Service Bulletin

43-066

DEF tank covers may become loose and potentially crack on vehicles built before October 2019 with DEF tank part number M86-6221-003** (TANK-DEF MEDIUM ASSY) and M86-6222-003** (TANK-DEF LARGE, ASSY).

Damaged or Loose DEF Tank Cover

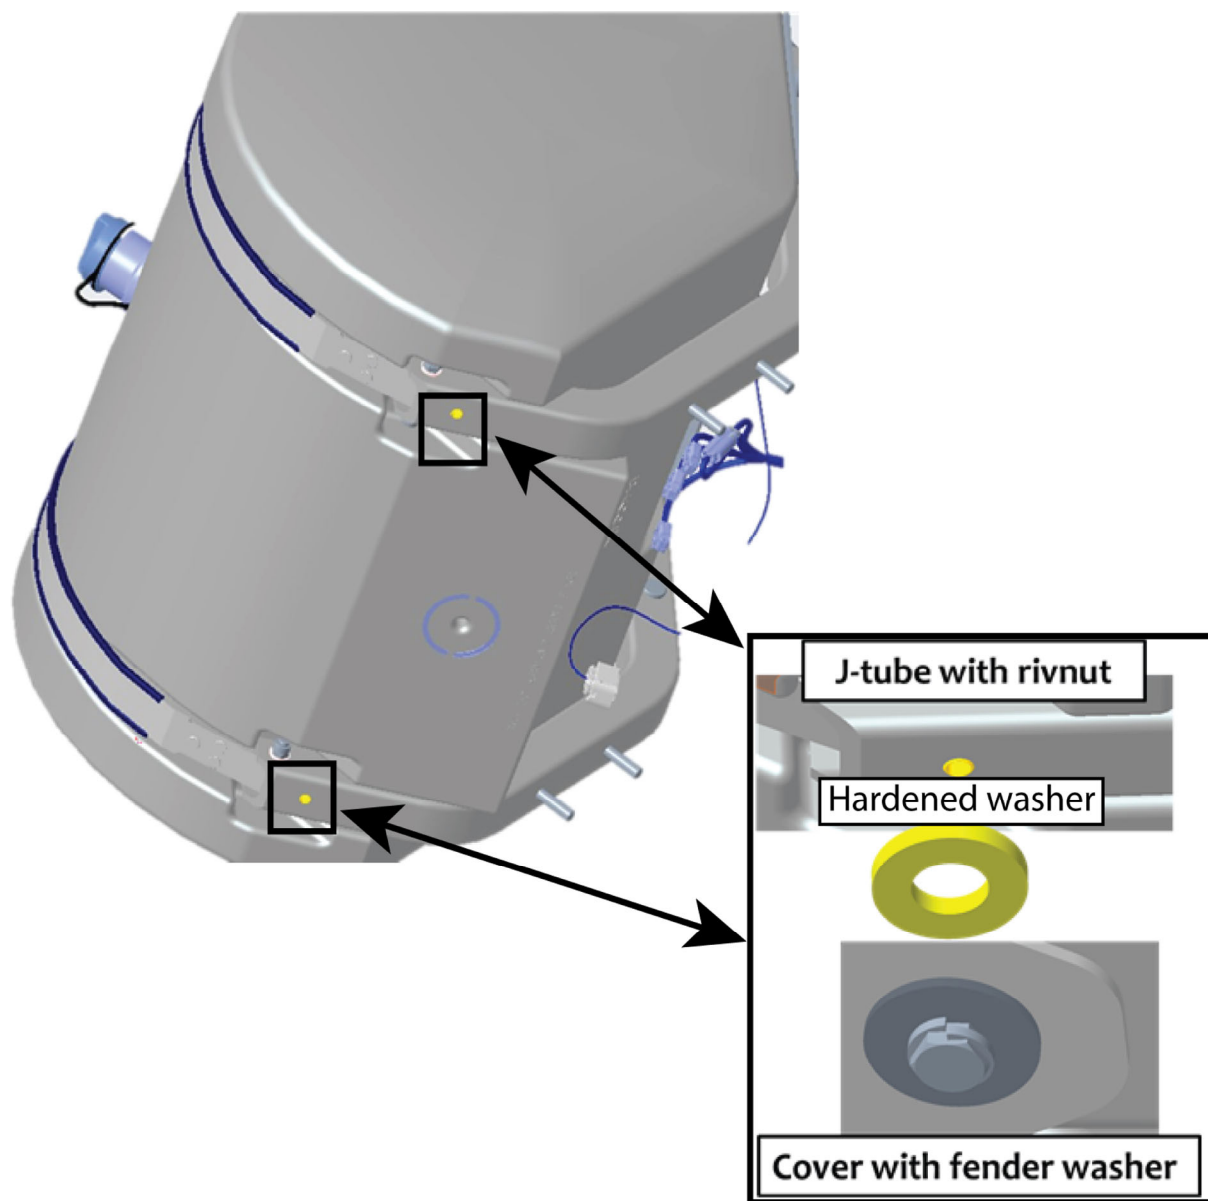
Peterbilt has determined that vehicles may experience excessive vibration on the DEF tank cover M22-6107 (COVER-DEF TANK, MEDIUM) and M22-6108 (COVER-DEF TANK, LARGE) due to lack of washers on underside of the DEF tank M86-6221-003** (TANK-DEF MEDIUM, ASSY) AND M86-6222-003** (TANK-DEF LARGE, ASSY). This excessive vibration can result in a loose DEF tank cover or damage to the DEF tank cover.

Remove the two lower bolts to the cover and place the washers as shown below:

- The hardened washer inner diameter surrounds the rivnut as shown in the image above. This washer will be sandwiched between the J-tube and the cover.
- The black fender washer is installed outside the cover, in contact with the lock washer.

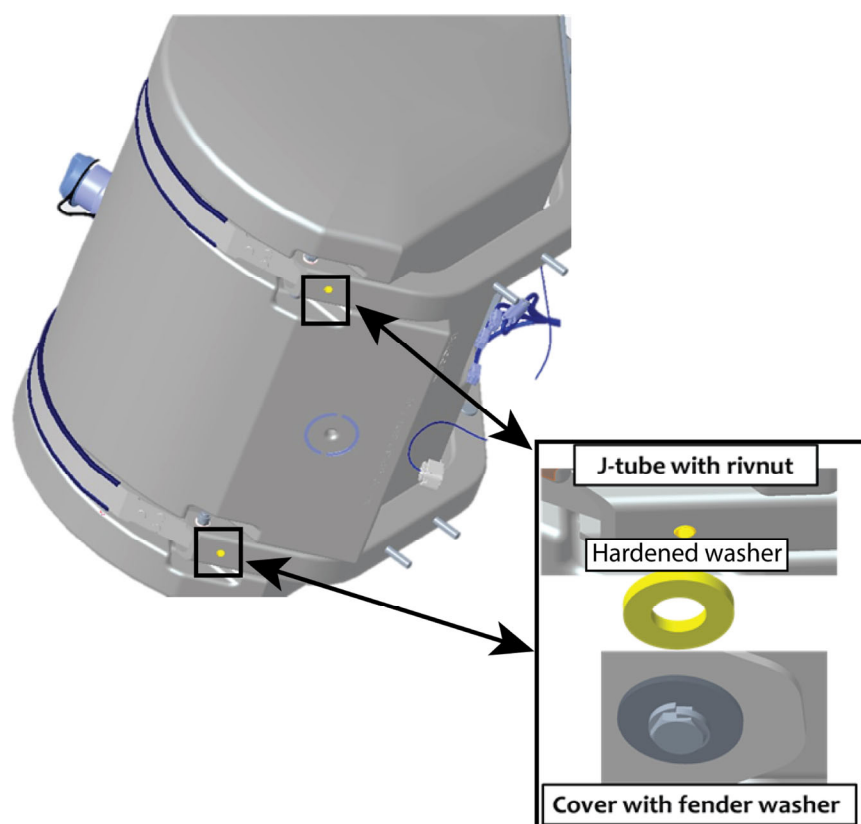
DEF tank covers may become loose, causing the cover to vibrate and potentially crack.

Remove the two lower bolts to the cover and place the washers as shown below:

- The hardened washer inner diameter surrounds the rivnut as show in the image below. This washer will be sandwiched between the J-tube and the cover.
- The black fender washer is installed outside the cover, in contact with the lock washer.
